ONTGOMERY COUNTY HISTORIC PRESERVATION COMMISSION
STAFF REPORT

Address:	6403 Connecticut Ave.	Meeting Date:	7/12/17
Resource:	Contributing Resource Chevy Chase Village Historic District	Report Date:	7/5/17
Review:	HAWP	Public Notice:	6/28/17
Case Number:	35/13-170	Tax Credit:	None
Applicant:	Jessica Killin & Raj Date	Staff:	Dan Bruechert
Proposal:	Accessory Structure Construction

PROPOSAL

Figure 1: Neighboring houses with detached garages circled

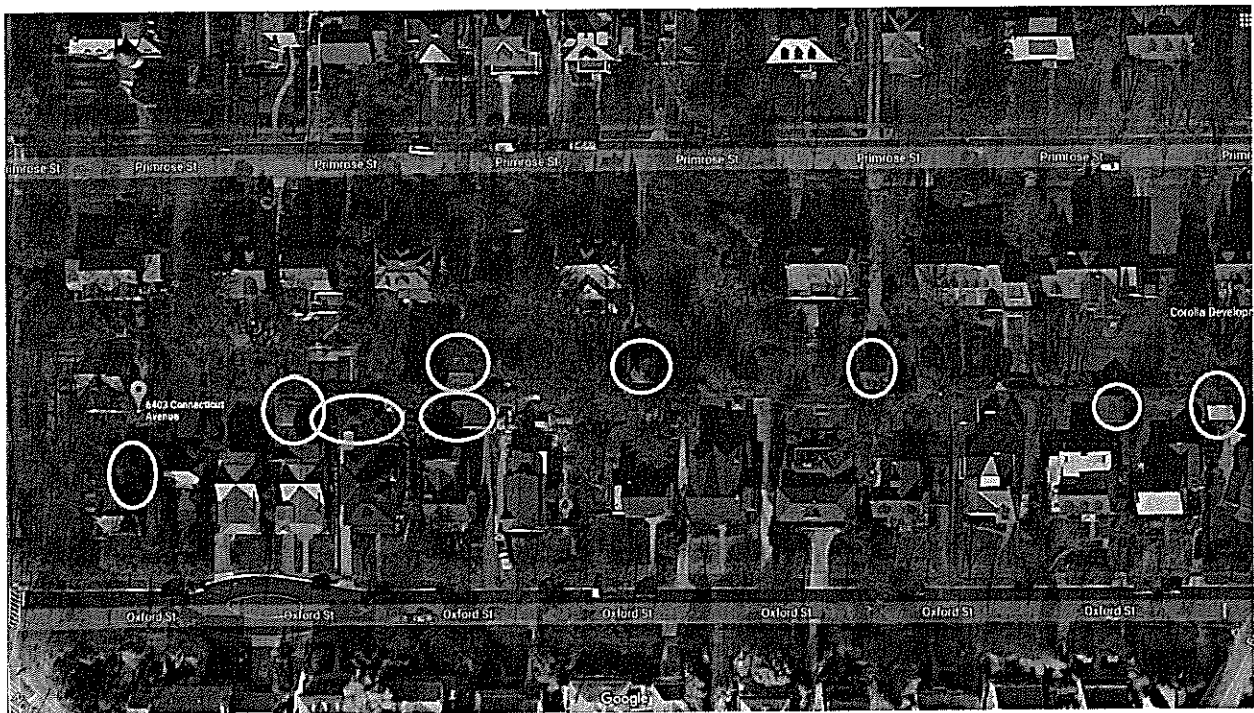
In 2016, when this property was brought before the HPC the Commissioners questioned whether it would be appropriate to construct a garage to meet the parking needs of the previous applicant (see circle: 4060). In that meeting the previous applicant indicated that there had been a garage in the northeast corner of the house, but the prior owner removed the garage when they constructed the kitchen addition to the north of the house (the left-side addition, largely obscured by a wooden fence). There is a precedent for a detached accessory structure on the property and as figure 1 demonstrates, several of the neighboring homes within the Chevy Chase Village Historic District have detached garages as well. The placement and location proposed in this HAWP is in keeping placement and character of detached garages with the surrounding district.

Chevy Chase Village Historic District *Design Guidelines* state that detached garages and accessory structures should be subject to lenient scrutiny but should be compatible with the main building. In this instance, the building will be placed in the rear of the lot and will not share any party walls with the house. Additionally, the architectural design takes cues from the historic house to create a cohesive appearance between the historic house and the accessory structure. The materials chosen for the accessory structure are the largely identical to those found in the historic; i.e. stucco siding, brick water table, cedar shingles, and multi-lite casement windows. The proposed asphalt shingles
